1. Modified Tree identify

1.3. Tree-ID state machine

Figure 1 : Modified Tree-ID state machine

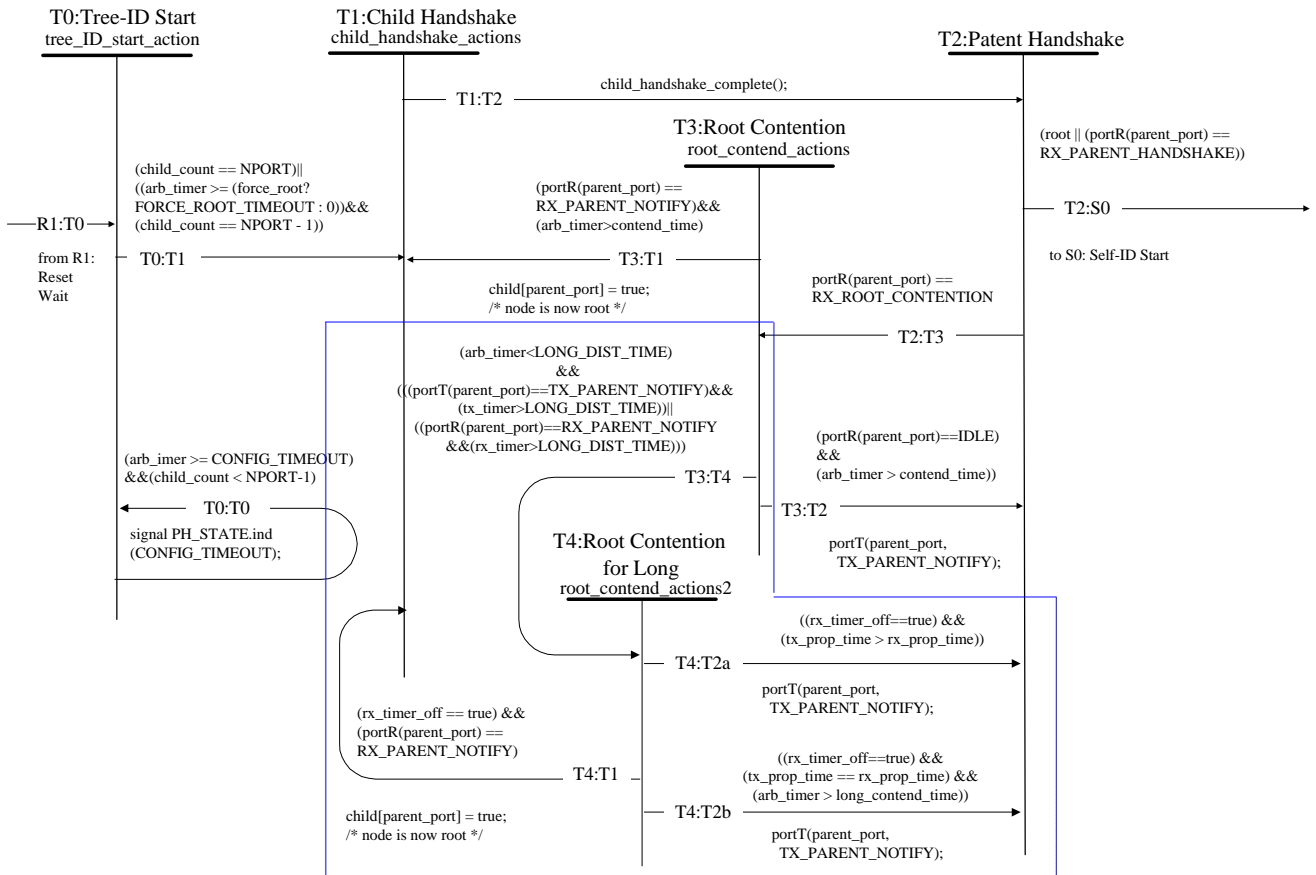
The parts enclosed by blue dashed lines is added.

State T4 : Root Contention for long cable. At this point, both nodes compare the duration of `tx_parent_notify` and the duration of `rx_parent_notify`. If the duration of `tx_parent_notify` is longer than the duration of `rx_parent_notify`, the node will be child node. If the duration of `rx_parent_notify` is longer than the duration of `tx_parent_notify`, the node will be parent node, that is, root.

Transition T3 : T4. When `tx_timer` or `rx_timer` is more than `LONG_DIST_TIME`, the resolution method for long cable is applied.

Transition T4 : T1. If the duration of `rx_parent_notify` is longer than the duration of `tx_parent_notify` and the node receives the `rx_parent_notify`, the node take on the role of bus root.

Transition T4 : T2a. If the duration of `tx_parent_notify` is longer than the duration of

rx_parent_notify, the node once again sends the tx_parent_notify signal.

Transition T4 : T2b. If the duration of tx_parent_notify is equal to the duration of rx_parent_notify, the nodes wait for long_contend_time in state T4, then once again send the tx_parent_notify signal.
